Re: Submission for State Significant Infrastructure - Warragamba Dam Raising Project (SSI-8441)

Attachment A – Detailed Comments

Figure 2 - South Creek 1%AEP flood extend and PMF flood extent

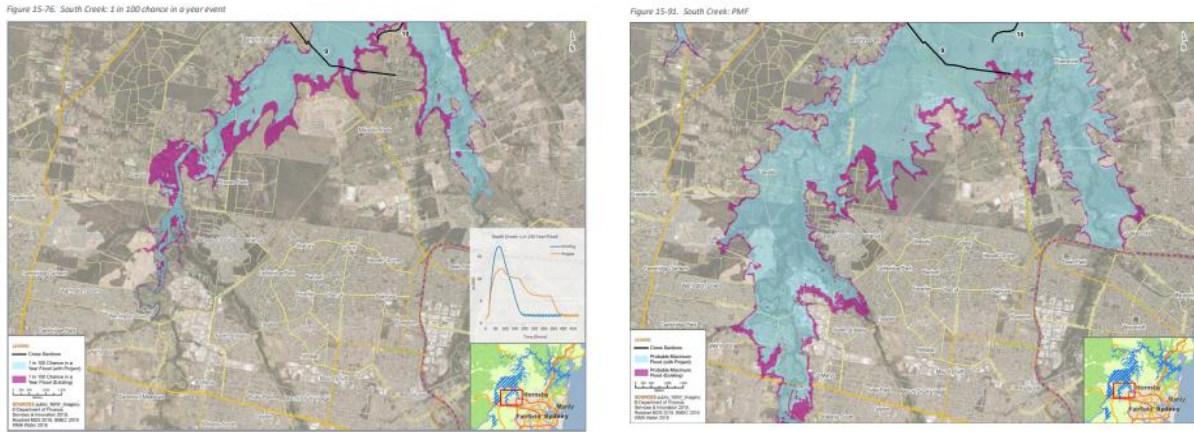
South Creek: The proposed dam raising project would provide significant flood risk management benefits in South Creek catchment. The peak 1% AEP flood level would be reduced by approximately 4 metres. The flood benefits from reduced flood depth will be contained within the Penrith LGA as shown in the figure below.

Figure 3 - 1%AEP flood extent at Wallacia and PMF flood extent at Wallacia

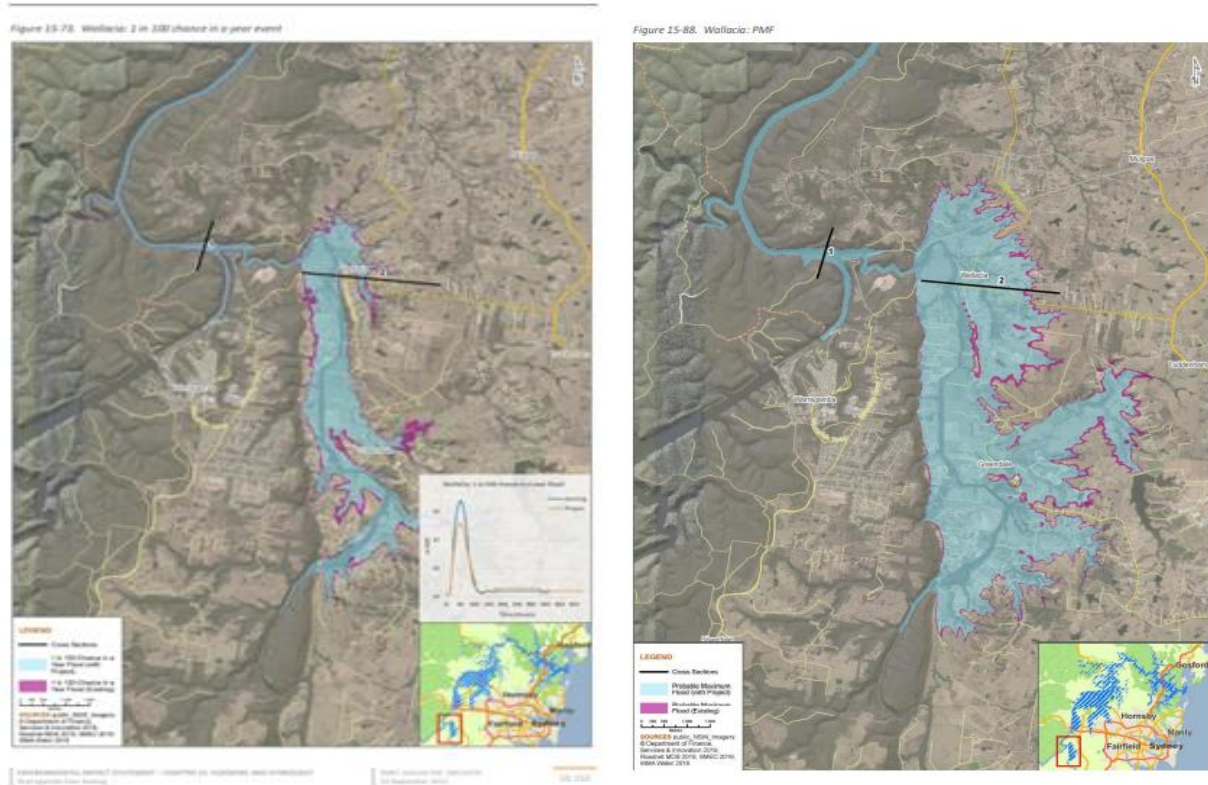
Wallacia/Greendale: The proposed dam raising works would provide significant flood risk management benefits in Wallacia and Greendale within the Liverpool LGA. The peak flood depth will be reduced by approximately 4 metres in the 1% AEP flood event as shown in the flood maps below.
